ADDENDUM No. 1

ITB No. 4706

WWTP HEADWORKS IMPROVEMENT PROJECT

SCALE: NTS
DRAWING No.: 804
SHEET No.: I-03A

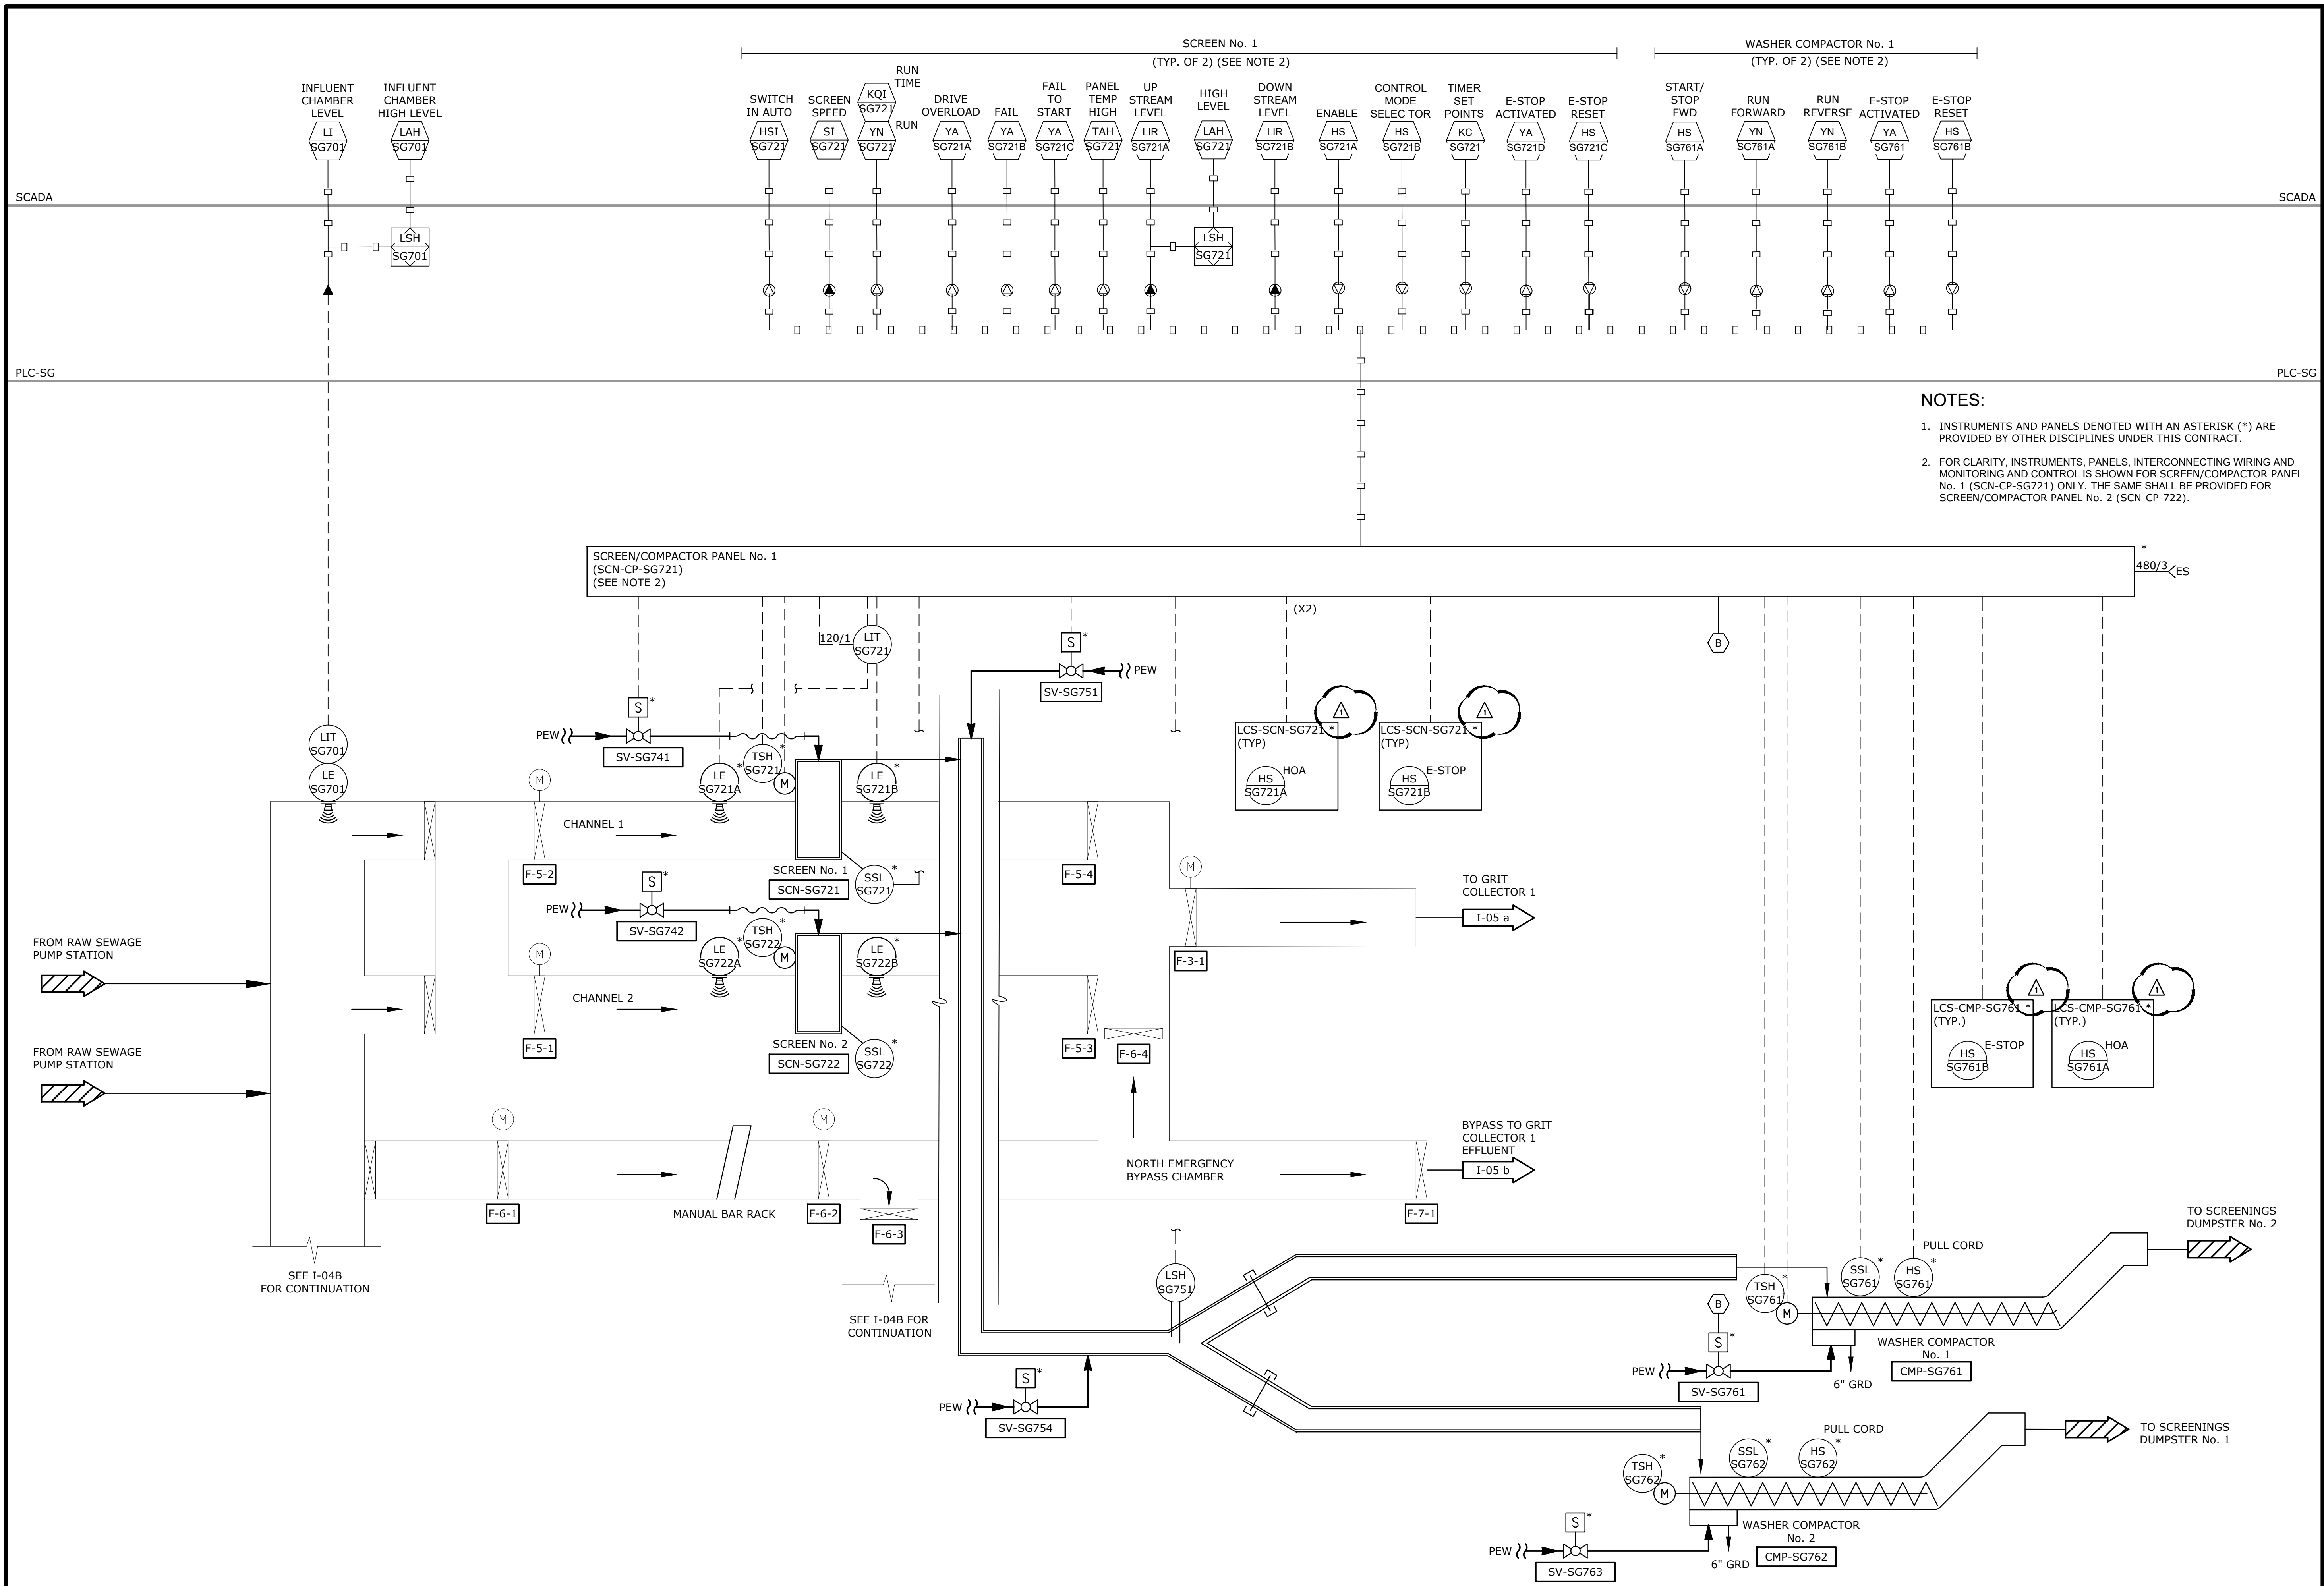
Question 32: Refer to sheet I-03A. Instrument LSH-SG751 does not appear in the Instrument list nor does it have an asterisk beside it. Please specify what this instrument is and who supplies it?

Question 33: Reference sheets I-03A and I03B and specification section 11350. These two drawings show multiple Local Control Stations associated with the three Screening/Compactor Systems. We believe that local control stations are the ones that are required by Section 11350 Items 2.2.C.3. If this is correct, it would appear that there should be an asterisk by each of these local control stations on drawings I-03A and I-03B. Please clarify.

Answer 33: For consistency, an asterisk was added to the top right of each local control station (LCS). See Section 11350.2.7 and drawings I-3A and I-4A.
